Lot 3 and an undivided 1/21 share in Lot 22, District Lot 10348, Kootenay District Plan EPP109367 (see plan as to legal access)
(PID 031-478-395)
3. Regional District of East Kootenay – SweetWater Zoning & Floodplain Management Bylaw No. 2127, 2009, Section 3.03 which permits a secondary suite with a total floor space of not more than 70 m² when located within a detached garage, is varied to permit the total floor space of a secondary suite within a detached garage of 88.9 m².

Variance Rationale – Feyter Secondary Suite

Project: BP122678/79 - Feyter Secondary Suite

GARAGE ELEVATIONS

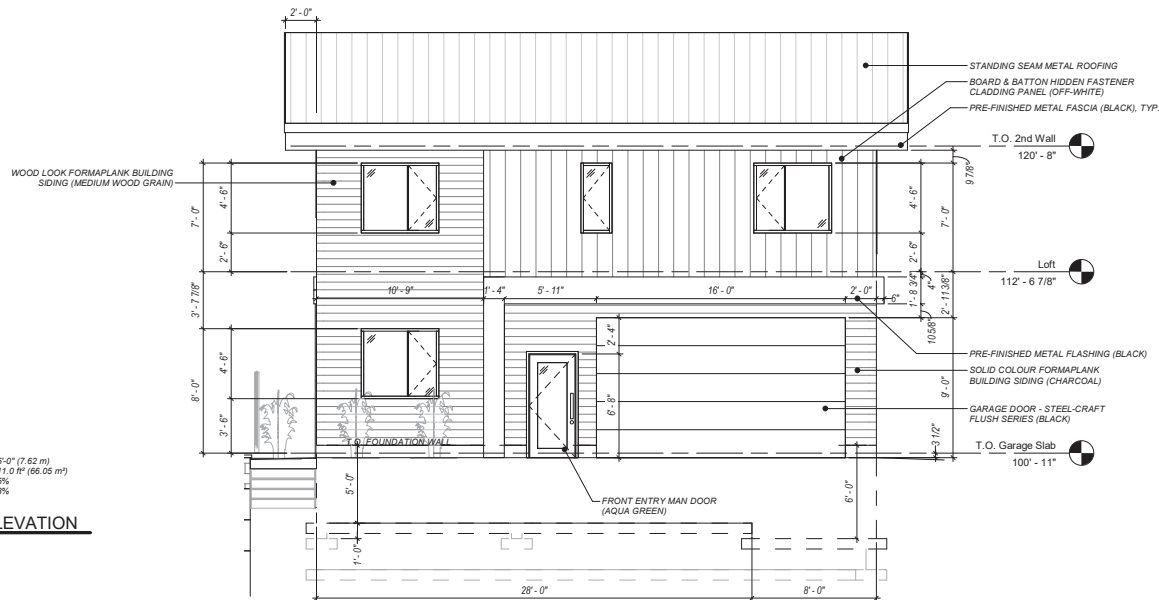
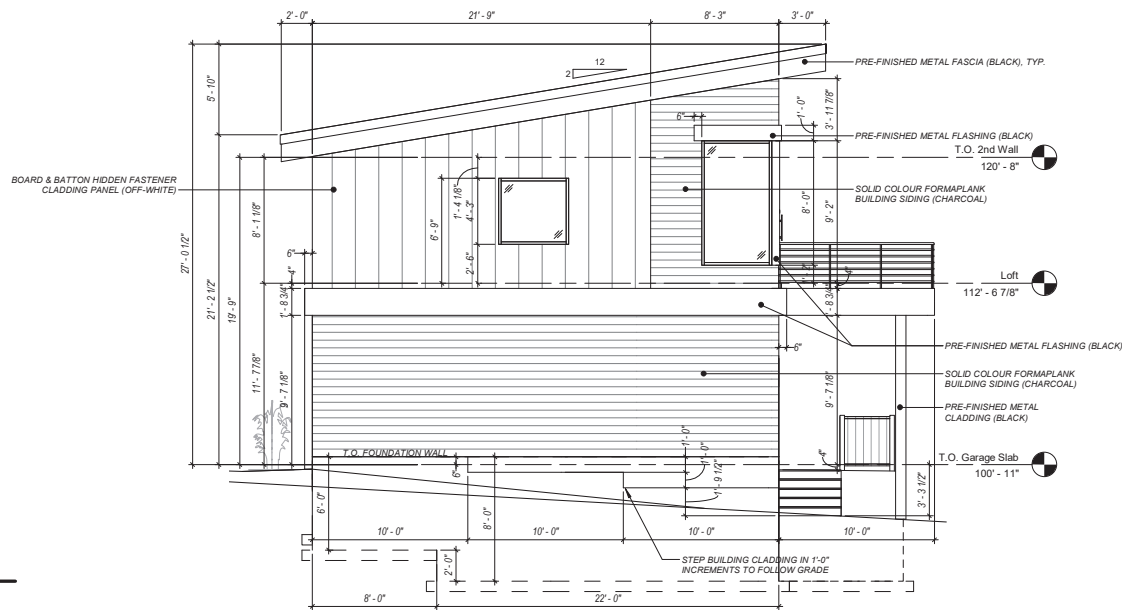
I left you a voicemail earlier today but have yet to hear back from you. In regards to this variance permit, isn't the proposed garage height level also a variance? It looks like as per paragraph 4.04 on page 7 of the attachment you sent that a secondary suite maximum height is 7.0M and this secondary building appears to be higher than that. Can you please clarify that?

Our additional concern with this building, besides that it is potentially going to be ~30% larger than current restrictions, is that it is not a garage with a suite above it, but rather a small house with a single garage bay. It looks like 75% suite and 25% garage. It will be like having two significant houses on the lot. The proposed garage/suite size likely also contributes to the positioning of the main house being located closer to the shoreline which impedes views of others, however I realize there is no restriction on placement of a house on each lot.
